7 SUB2010-00016

MOBILE SOUTH BUSINESS PARK SUBDIVISION, UNIT ONE, RESUBDIVISION OF LOTS 13-A, 13-B & 14

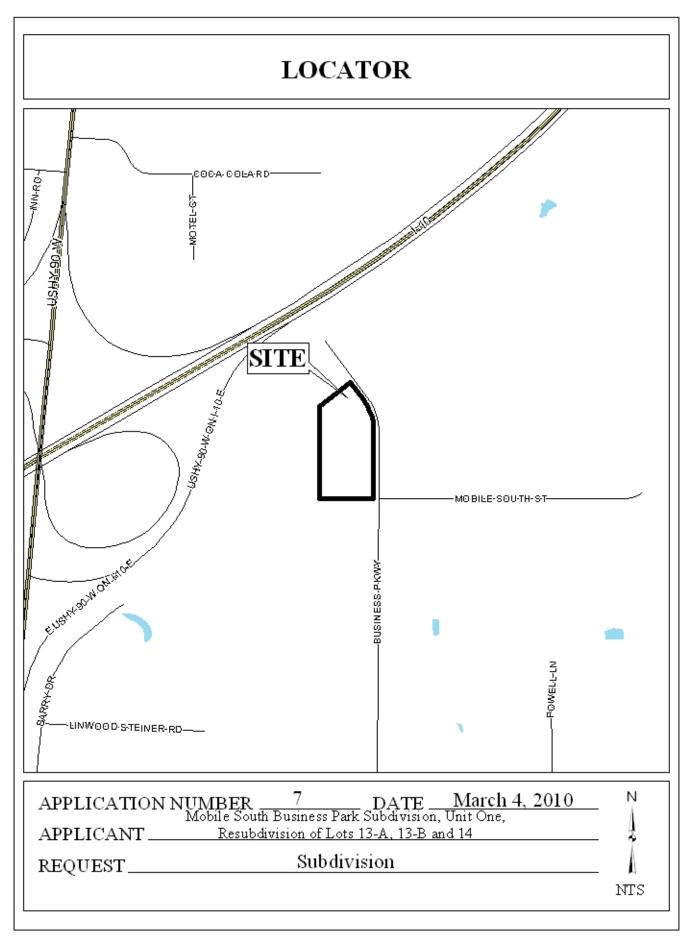
The site fronts Business Parkway, a minor street provided with curb and gutter, illustrating 60' of right-of-way; thus, no dedication is required.

Although Business Parkway is a minor street, access management is still a concern; therefore, a note should be placed on the Final Plat stating that the subdivision is limited to the existing curbcuts along Business Parkway with the size, location, and design of any additional curb-cuts to be approved by Traffic Engineering and conform to AASHTO standards.

Both lots are labeled on the plat with its size in square feet, and should be retained on the Final Plat, or a table should be provided furnishing the same information.

It should be noted that the preliminary plat illustrates a 50' minimum building setback line, and only a 25' setback line is required.

- 1) placement of a note on the Final Plat stating that the subdivision is limited to the existing curb-cuts along Business Parkway with the size, location, and design of any additional curb-cuts to be approved by Traffic Engineering and conform to AASHTO standards;
- 2) placement of a note on the Final Plat stating that approval of all applicable Federal, state and local agencies for endangered, threatened or otherwise protected species is required prior to the issuance of any permits or land disturbance activities; and
- 3) full compliance with all municipal codes and ordinances.
